8.2 Master Responses

8.2.1 Master Response 1: EIR/EIS Authorship

8.2.2 Master Response 2: Source Water Components and Definitions

Figure 8.2.6-1
DWR SGMA Basin Map

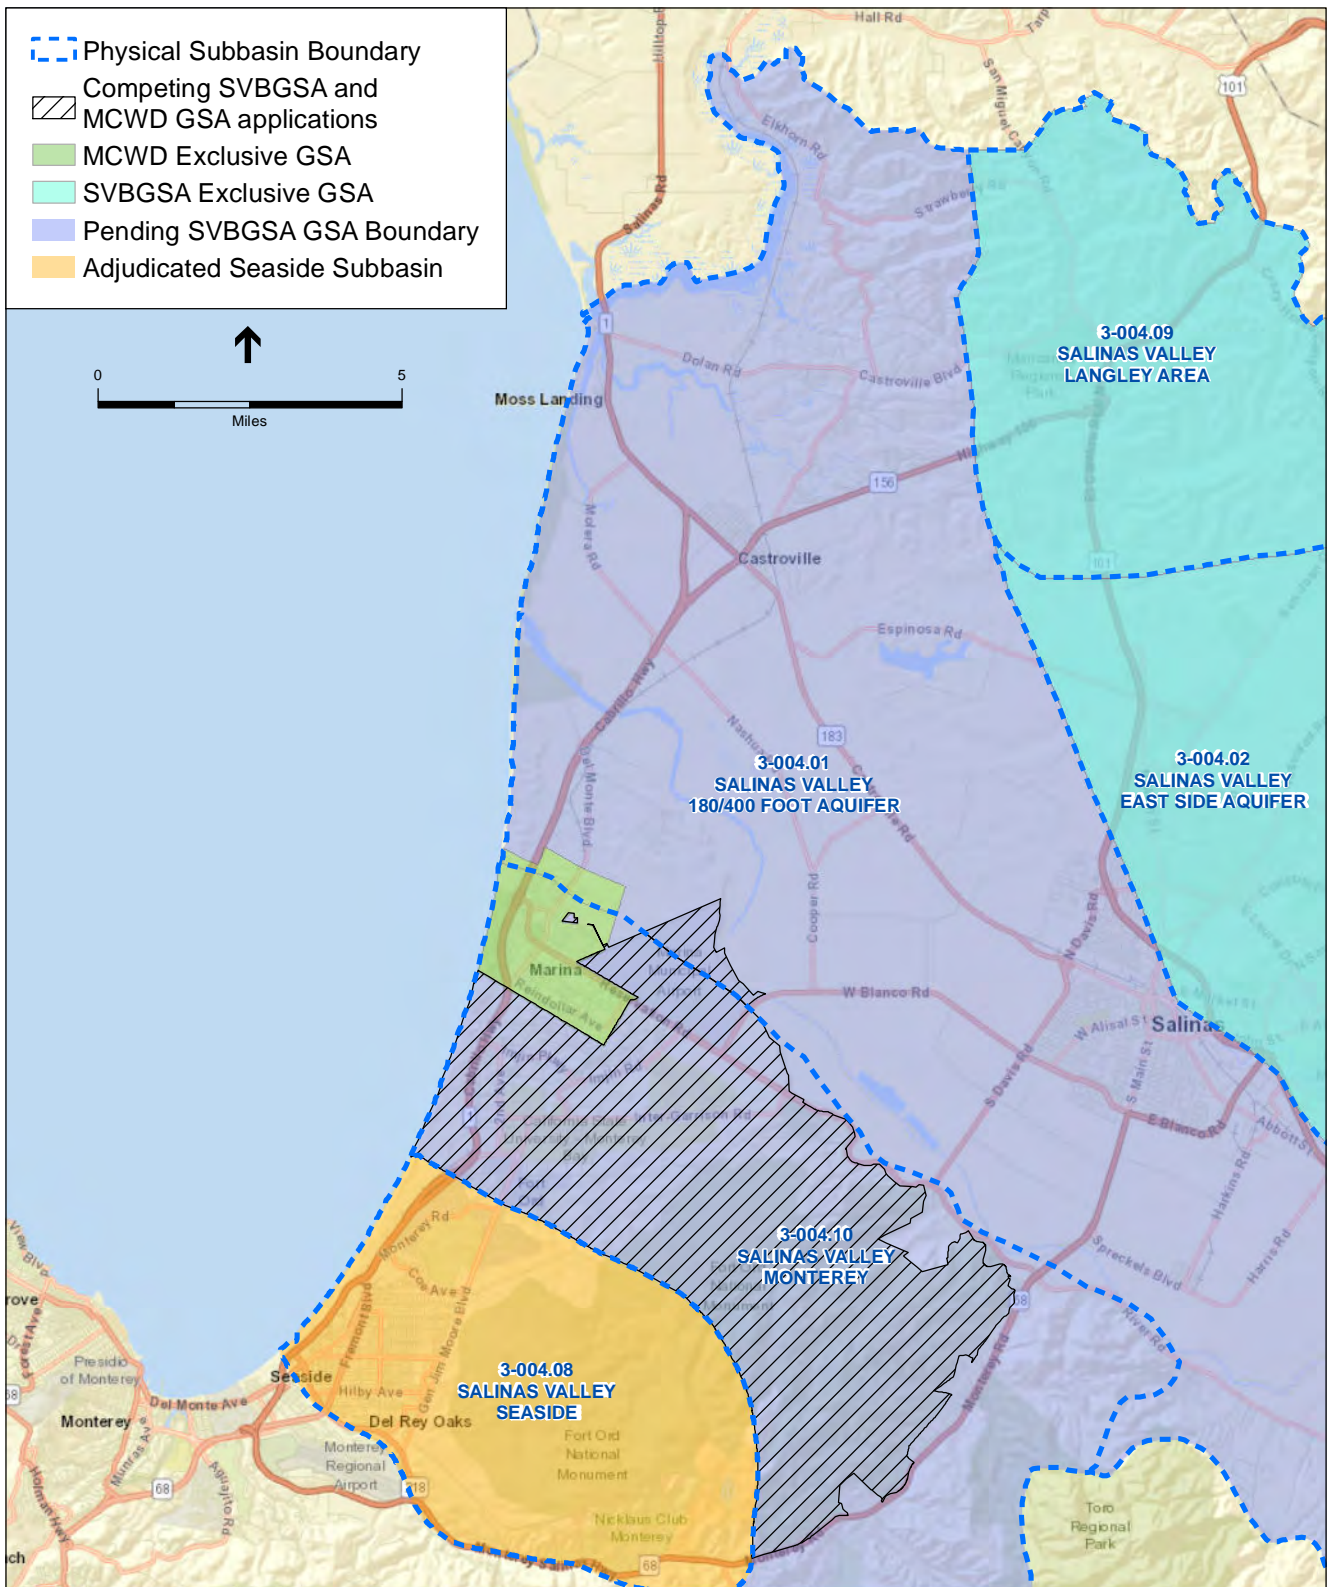
The designation of groundwater basins has evolved over time as new information has become available. As shown on EIR/EIS Figure 4.4-1, the basin boundaries designated by the DWR in 2012 (colored polygons) differ from the basin boundaries designated by DWR in 1946 (black outlines). Note that the names of the subbasins have also evolved over time. Local agencies such as the Monterey County Water Resources Agency (MCWRA) have used some different basin names and delineations based on their locally available information and understanding of basin boundaries. The proposed source water intake system, for example, would be located in the 180/400 Foot Aquifer Subbasin, the boundaries of which generally coincide with those of the SVGB Pressure Area (or Subbasin) traditionally recognized by MCWRA and DWR. The basin borders are described in EIR/EIS Section 4.4.1.2.

The MCWD is a water agency that provides water supply for: the Central Marina service area, which consists of most of the City of Marina, and; the Ord Community service area, which includes some western portions of the former Ford Ord military base. The DWR has accepted the MCWD as the exclusive GSA within the Central Marina service area, most of which is in the northwestern portion of Salinas Valley Monterey Basin 3-004.10 but extends into a small portion of the Salinas Valley Monterey Basin 3-004.10 to the north, shown as the green area on Figure 8.2.6-1.

The SVBGSA has submitted a GSA formation request to the DWR for all of the Salinas Valley Monterey Basin 3-004.10, except for the above-described MCWD Central Marina service area. However, the MCWD has also submitted a proposal to the DWR to have the MCWD be the GSA for a larger portion of the Salinas Valley Monterey Basin 3-004.10 than merely the area within the MCWD Central Marina service area. The MCWD request includes its Ord Community service area, but also extends further east into areas not served by the MCWD. The DWR GSA formation decision on the diagonal shaded area on Figure 8.2.6-1 is pending.

Figure 8.2.8-1
 Extent of Capture Zone and -1-Foot Contour of Cone of Depression
 Dune Sand Aquifer After 63 years
 0% Return Water

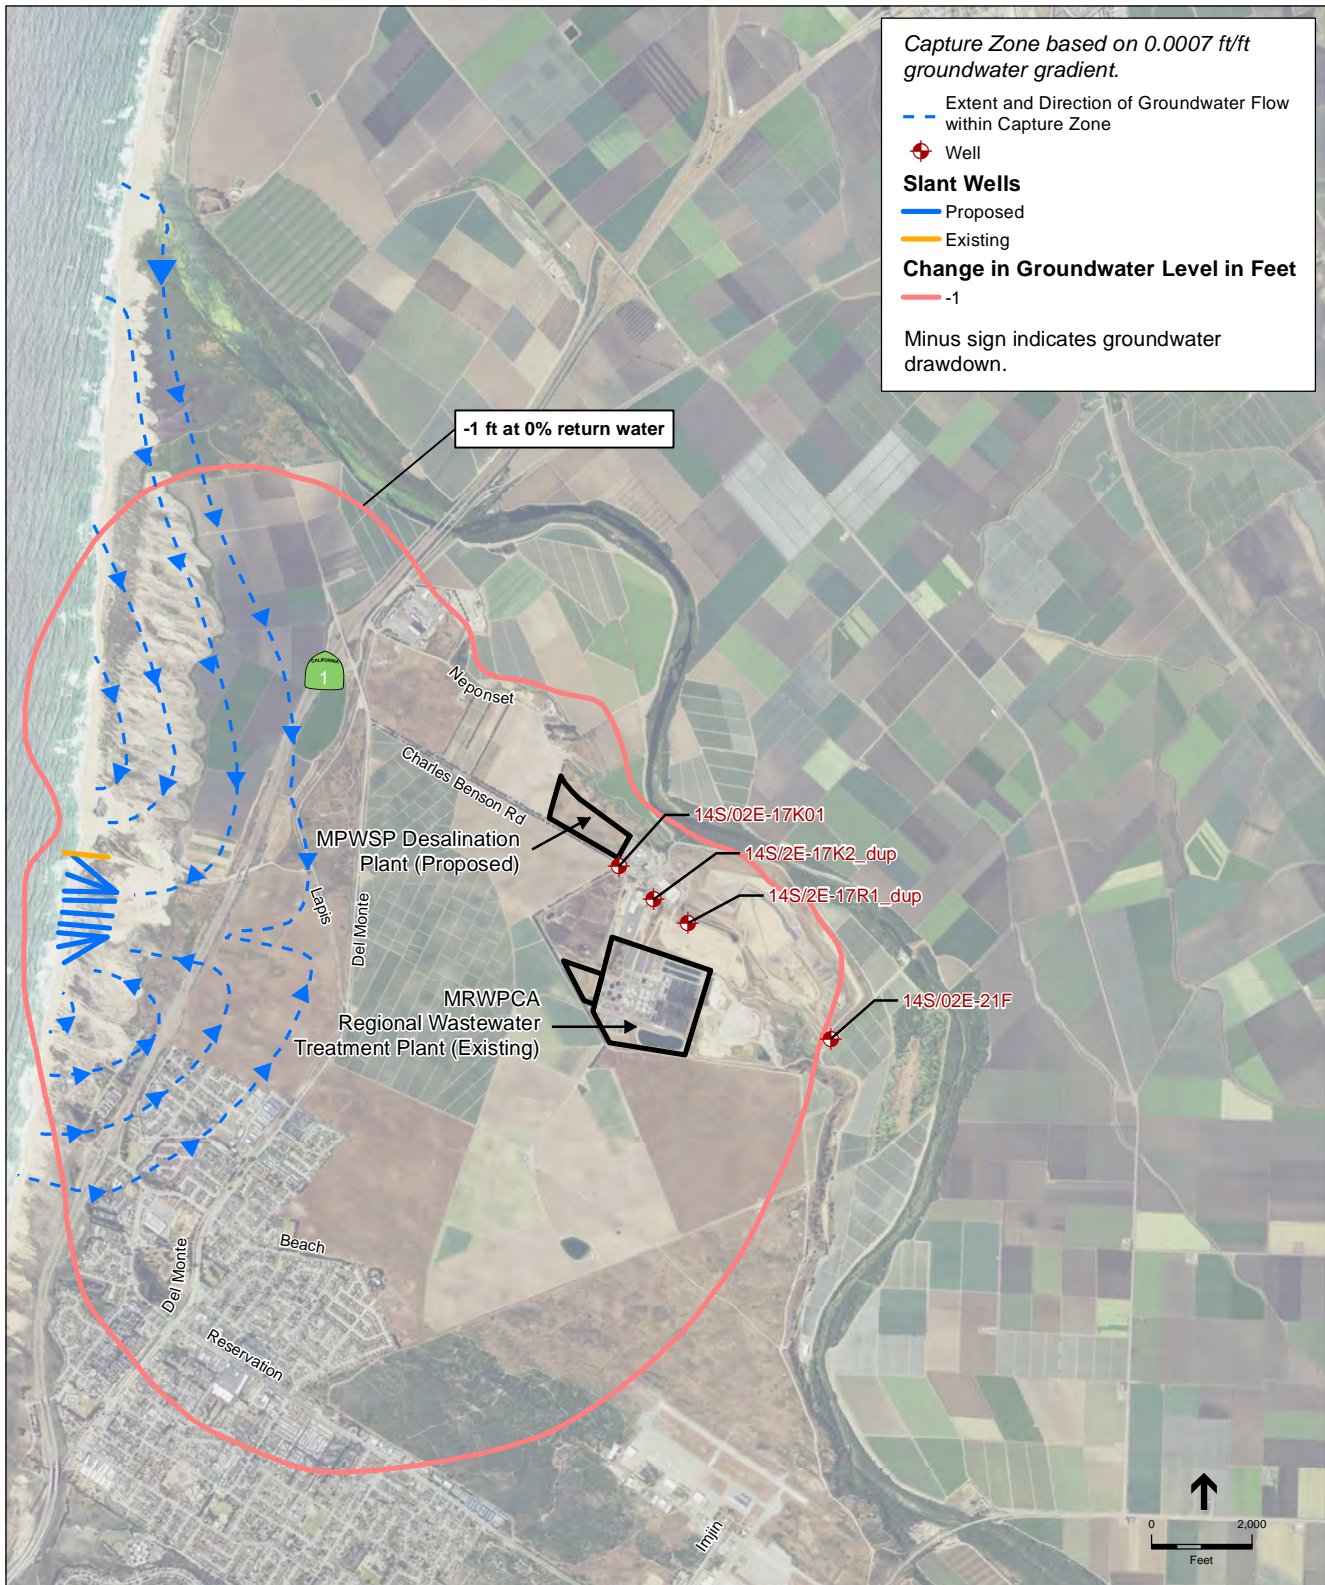
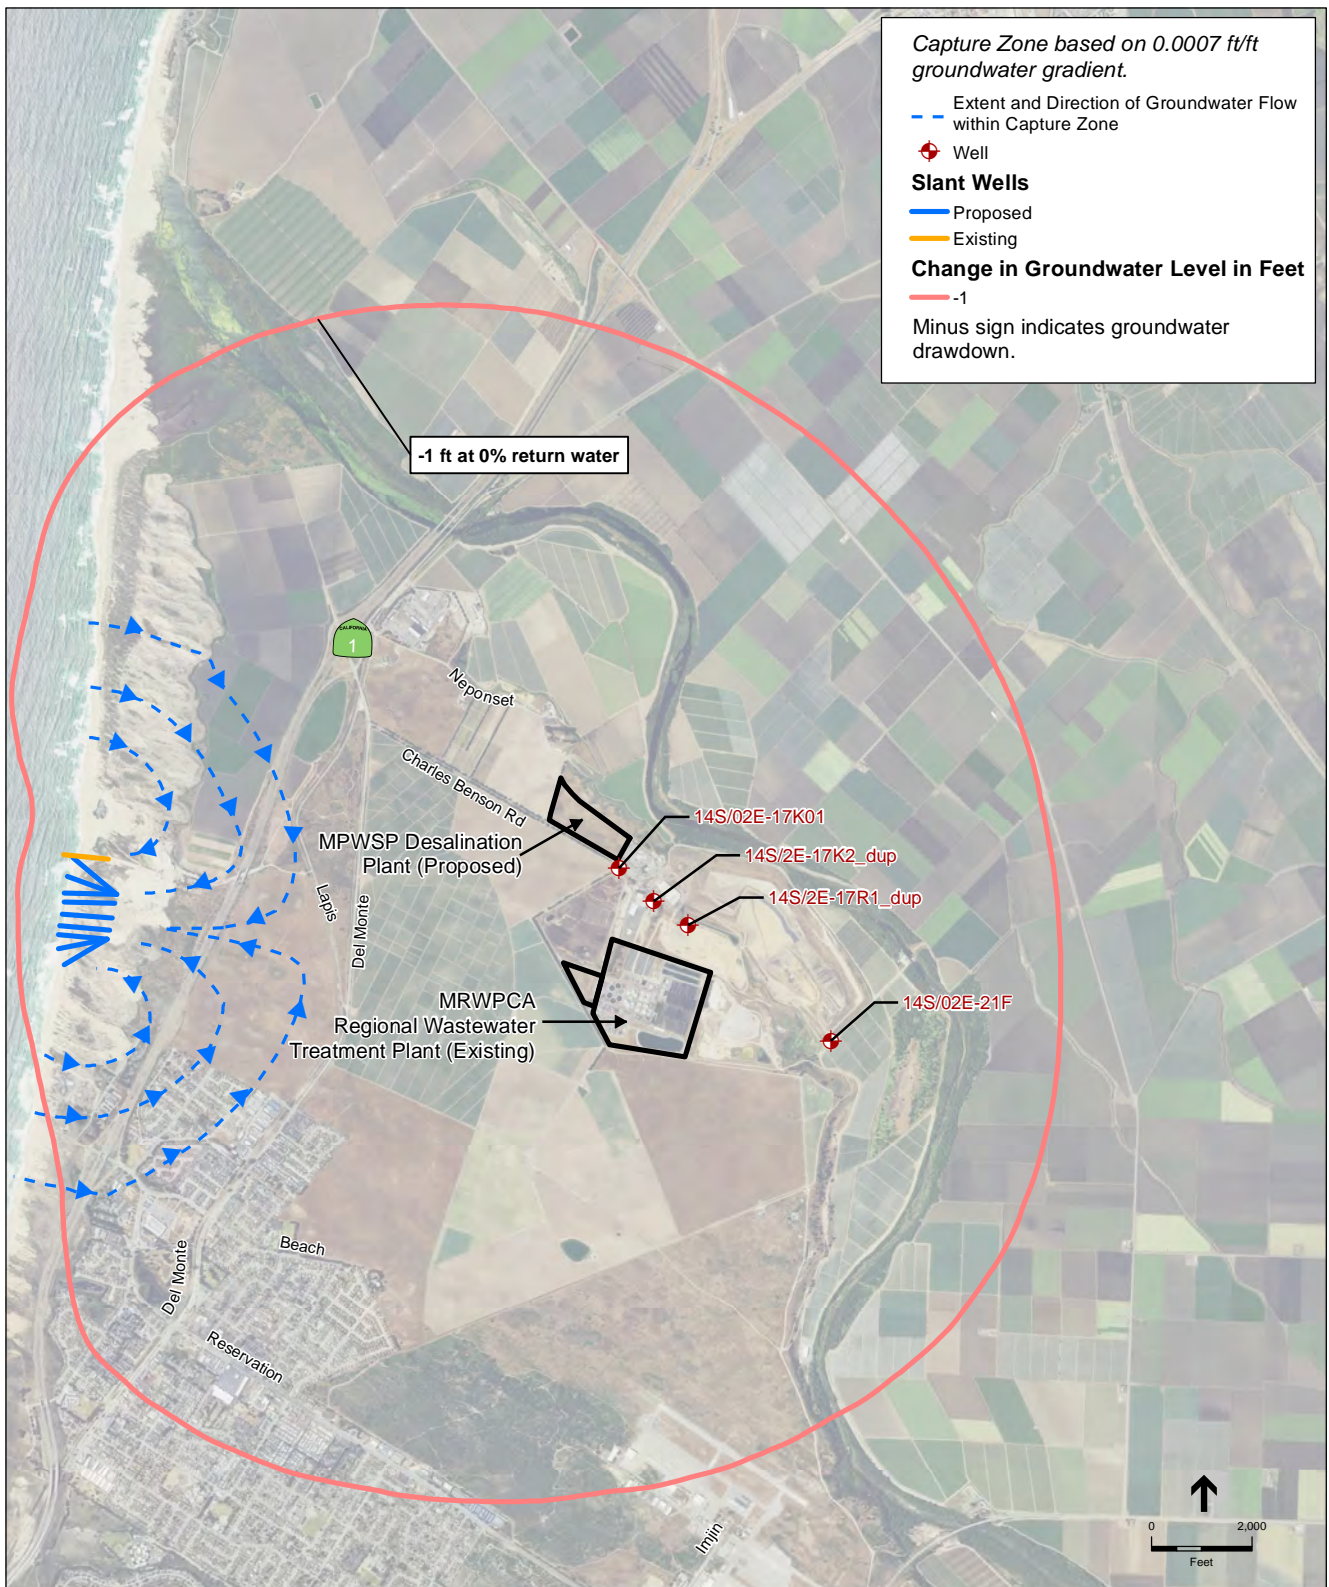
Draft EIR/EIS Figure 4.4-13 depicted this modelled cone of depression, represented by contour lines of equal drawdown, in the 180-Foot Aquifer. This figure has been renumbered 4.4-13a in the Final EIR/EIS, and Figure 4.4-13b has been added to Final EIR/EIS Section 4.4 to show the modelled cone of depression in the Dune Sand Aquifer.

The 2016 version of the North Marina Groundwater Model (NMGWM²⁰¹⁶) projects that this drawdown would occur as a result of a slant well extraction rate of 24.1 million gallons per day (mgd). This is considered “worst-case” because it represents the cone of depression in the Dune Sand Aquifer under 2012 sea level conditions and 0 percent return water. Final EIR/EIS Figure 4.4-13a shows the cone of depression for the 180-FTE Aquifer as projected by the NMGWM²⁰¹⁶. This is also considered the worst-case drawdown condition under the proposed 24.1 mgd pumping scenario. The cones of depression for both the Dune Sand Aquifer and 180-FTE Aquifer are similar: steep contours just offshore along the western extent and flatter to the east, forming a cone of depression that extends inland with drawdown amounts ranging between 1 to 5 feet. As discussed in EIR/EIS Section 4.4.4.2, Groundwater Modeling, the area or radius of pumping influence demarks the extent that water levels would decrease (or be drawn down) by the extraction of groundwater at the slant wells. For purposes of the impact analysis in the EIR/EIS, the extent of the radius of influence was marked by the one-foot drawdown contour of the cone of depression.

Figure 8.2.8-3
Schematic Showing Relationship Between
Cone of Depression and Capture Zone

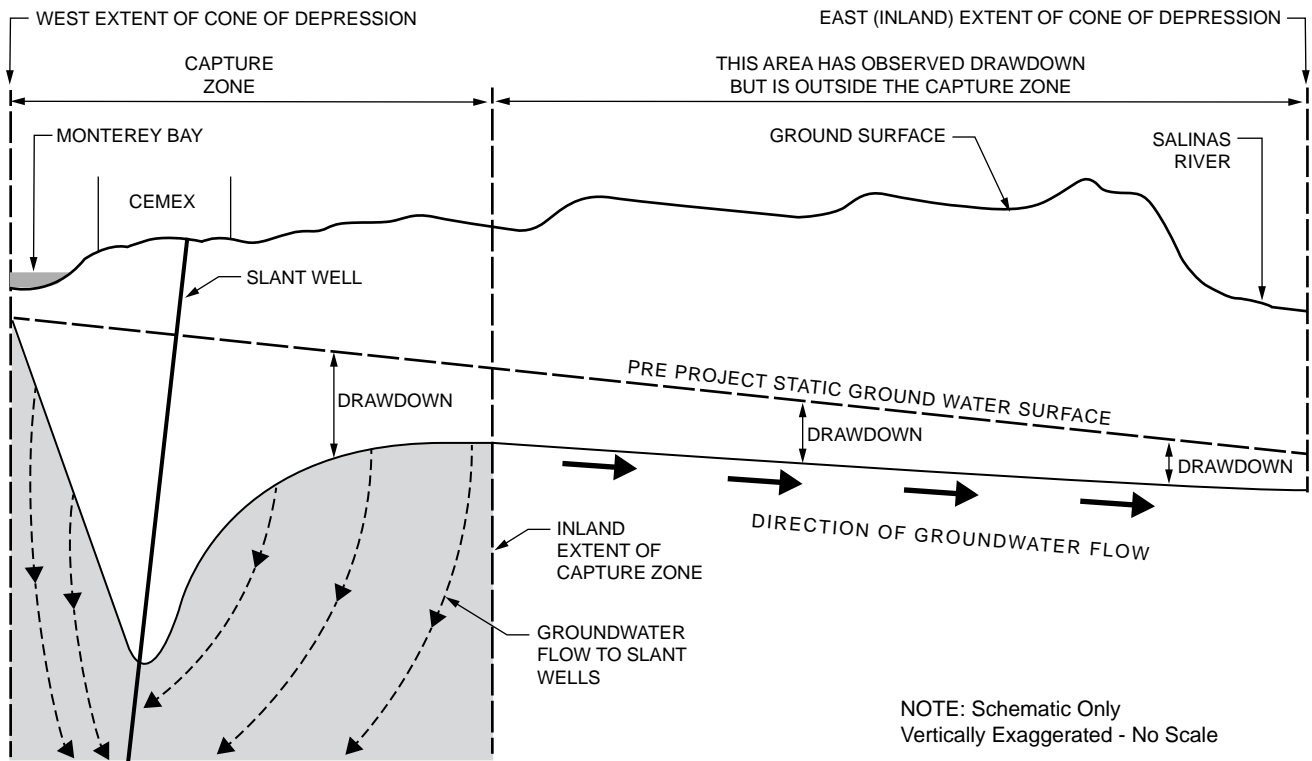
The cone of depression that forms from groundwater pumping and the capture zone that provides source water to the slant wells are not the same. **Figure 8.2.8-3** is a cross-sectional schematic that illustrates the relationship between the cone of depression (shown in map view on Figure 4.4-13a) and capture zone (shown in map view on Figure 8.2.8-2) under a “Pre-Project” and “Project” condition. Under the Pre-Project Condition (shown at the top of Figure 8.2.8-3), the groundwater is flowing inland from the coast at a gradient of 0.0005.⁵ The Pre-Project Condition represents the groundwater condition without accounting for current well pumping or groundwater recharge. The “Project Condition” represents how the groundwater would respond to project slant well pumping in the 180/180-FTE Aquifer, assuming 2012 sea level and no return water (both conservative assumptions), and is correlative to the map view of the cone of depression shown on EIR/EIS Figure 4.4-13a. It should be noted that the vertical scale is considerably exaggerated in the “Project Condition” to clearly illustrate the relationship between the cone of depression and the capture zone; for reference, the NMGWM²⁰¹⁶ projected that the maximum drawdown amount under this pumping scenario was about 29 feet at the slant wells. As illustrated in Figure 8.2.8-2, when the slant wells are pumping, water within the capture zone would be drawn into the wells from the surrounding sediments. The groundwater responds by creating a cone of depression, which would be most pronounced near the slant wells. Notice that the drawdown caused by slant well pumping decreases as the cone of depression extends eastward. The inland extent of the capture zone is shown by a vertical dashed line. This point could be described as a groundwater gradient divide: groundwater west of the divide is drawn into the capture zone by the slant wells and thus flows west, while the groundwater to the east of the boundary continues to flow inland unimpeded due to the regional gradient. The fundamental difference between the capture zone, which is supplying the water to the slant wells, and the cone of depression, which forms in response to pumping, is that the groundwater entering the slant wells originates only from within the capture zone, while the regional gradient controls the groundwater flow beyond the capture zone.
